ADDENDUM

Project: B.01 CT Site Prep

Addendum No.: 01

Date: 06/06/13

F3 AUXILIARY PLAN
SCALE: 1/8"=1'-0"

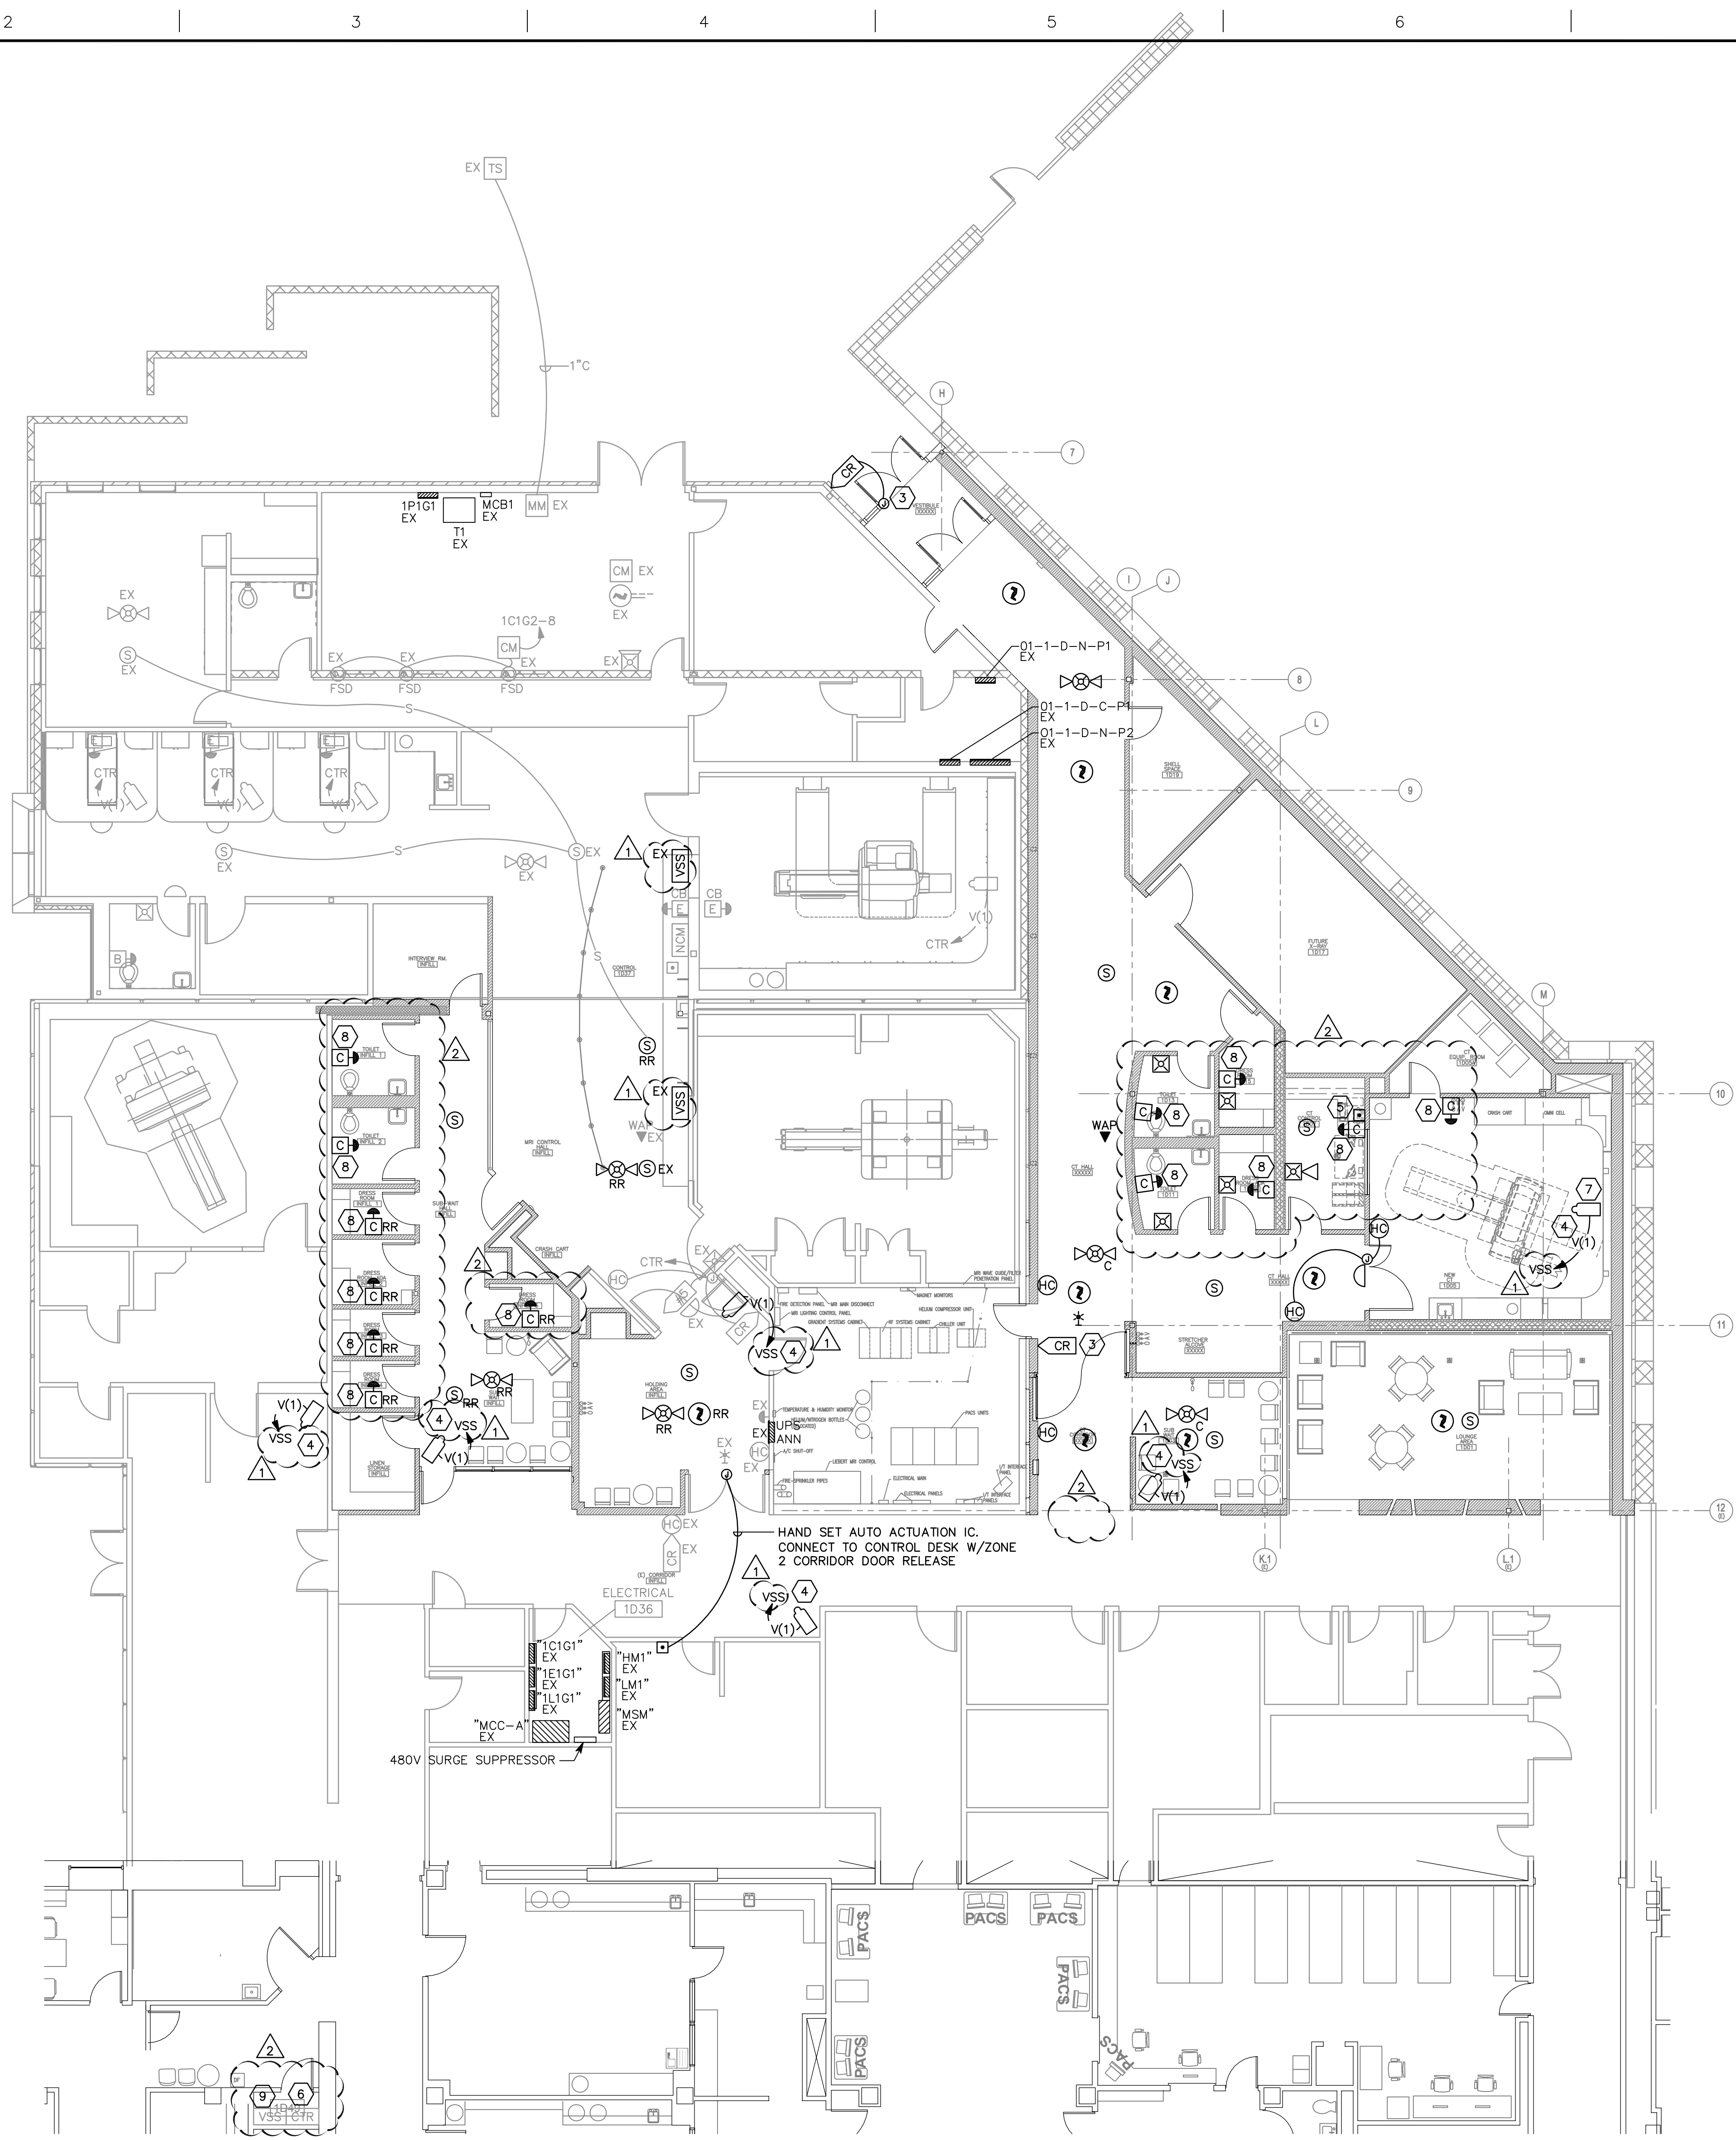
SHEET EY101 (See attached sheet)

1. Change nurse call system to wireless call assist system. Connect with wireless system installed in phase #1.

- EXISTING DOOR CONTROLLER (CTR). USE AN ADDITIONAL COMMUNICATION CARD INSTALLED IN PHASE 1.
- WALL MOUNT CAMERA IN CASEWORK.
- PROVIDE WIRELESS EMERGENCY CALL BUTTONS AT PATIENT PREP BED LOCATIONS, DRESSING ROOMS AND TOILET ROOMS. CALL BUTTON WILL ANNUNCIATE ON CCTV PC AT MRI CONTROL DESK, AND AT RECEPTIONIST DESK.

B1 CCTV PATIENT MONITORING SYSTEM DIAGRAM
NTS

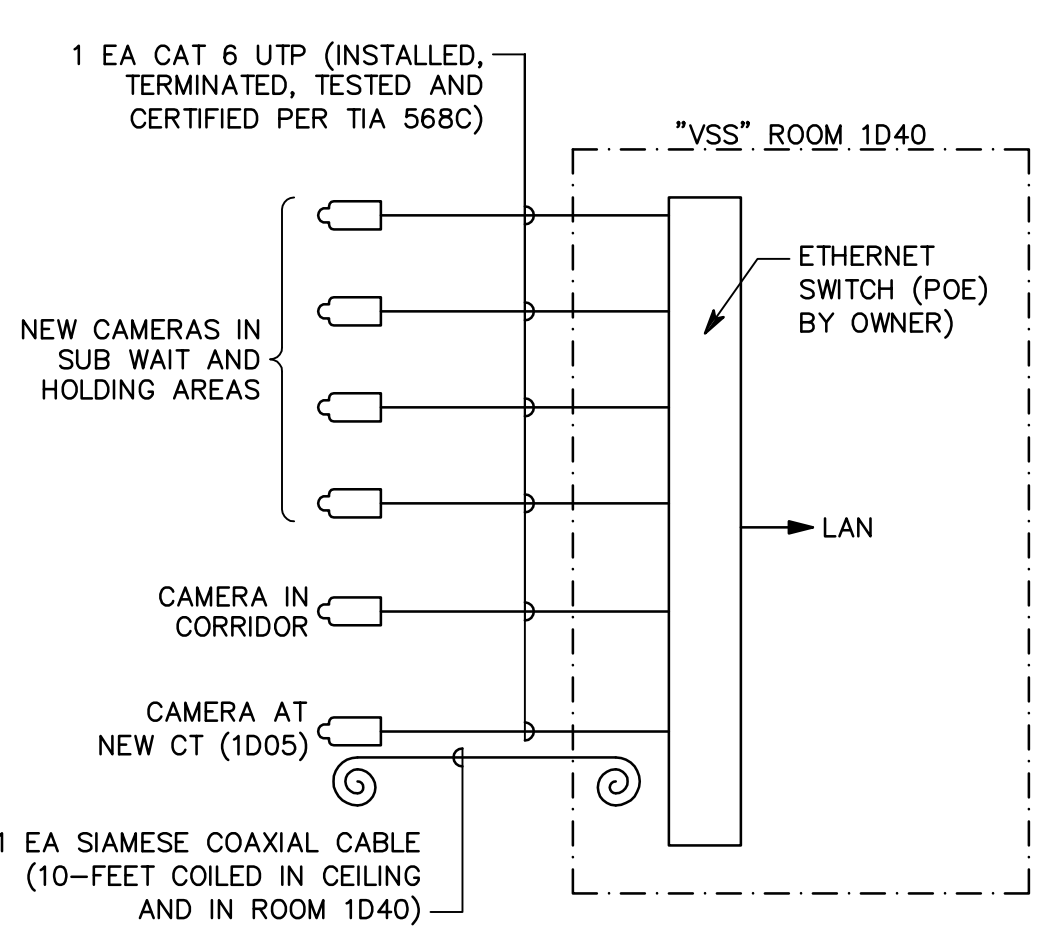
1. Revised detail B1 on sheet EY602 for CCTV system. Matches changes made in phase #1.
